Access Compliance Report Public Rights-of-Way (Curb Ramps)

Main Street: CIMA_DR		Cross Street: N/A		Location:	N
ADA ID: RPAT220125111714	Ramp Type:Type 1 - Perpendicular	Initial Pass/Fail: Fail	Overall Compliance: No	Severity Score:	15
Codes/Mitigation Info/Possible Solution			Field Measurements/Component Compliance

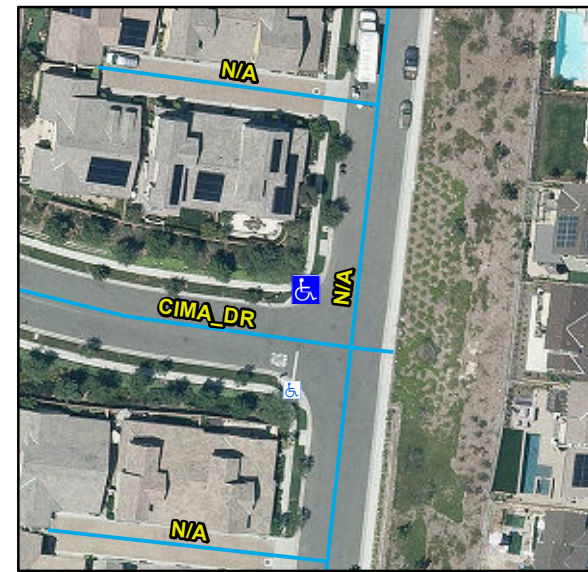
Compliance	Description	Data	Compliance	Description	Data
N/A	Ramp Length (in)	72	N/A	Flare Type LT	
Yes	Ramp Width (in)	96			N/A
No	Ramp Run Slope (%)	9.4	N/A	Flare Slope LT (%)	N/A
Yes	Ramp Cross Slope (%)	0.4	N/A	Flare Traversable LT	N/A
N/A	Landing Present	N/A	N/A	Flare Type RT	
N/A	Landing Length (in)	N/A			N/A
N/A	Landing Width (in)	N/A	N/A	Flare Slope RT (%)	N/A
N/A	Landing Run Slope (%)	N/A	N/A	Flare Traversable RT	N/A
N/A	Landing Cross Slope (%)	N/A	N/A	DWS Provided	N/A
N/A	Landing Movement Obstructed?	N/A	N/A	DWS Contrast	N/A
	Landing Movement Type	N/A	N/A	DWS Length (in)	N/A
N/A	Landing Shared	N/A	N/A	DWS Full Width	N/A
N/A	Clear Space	N/A	N/A	DWS Offset Left (in)	N/A
N/A	Clear Space To Crosswalk (in)	N/A	N/A	DWS Offset Right (in)	N/A
N/A	Marked Crosswalk 1	No	N/A	Marked Crosswalk 2	N/A
	Crossing 1 Direction	SW		Crossing 2 Direction	N/A
	Marked Crosswalk 1 Width (in)	N/A		Marked Crosswalk 2 Width (in)	N/A

N/A	Ramp Inside Crosswalk 1	N/A	Yes	Ramp Inside Crosswalk 2	N/A
	Crossing 1 Slope (%)	1.2		Crossing 2 Slope (%)	N/A
	Crossing 1 Cross Slope (%)	0.6		Crossing 2 Cross Slope (%)	N/A
N/A	Gutter Ponding	N/A	No	Curb Slope	6.3
Yes	Gutter Lip Height (in)	0		Road Run Slope (%)	N/A
N/A	Gutter Run Slope (%)	N/A		Road Cross Slope (%)	N/A
N/A	Gutter Cross Slope (%)	N/A			
Yes	Overall Surface Condition: Acceptable		Yes	Perp Joint Present	Yes
	Cross Gutter Present?	No		Spandrel Present?	No
	Replace Cross Gutter?	N/A		Replace Spandrel?	N/A

Remove & Replace Entire Ramp.

R304.2.2, STD 1115
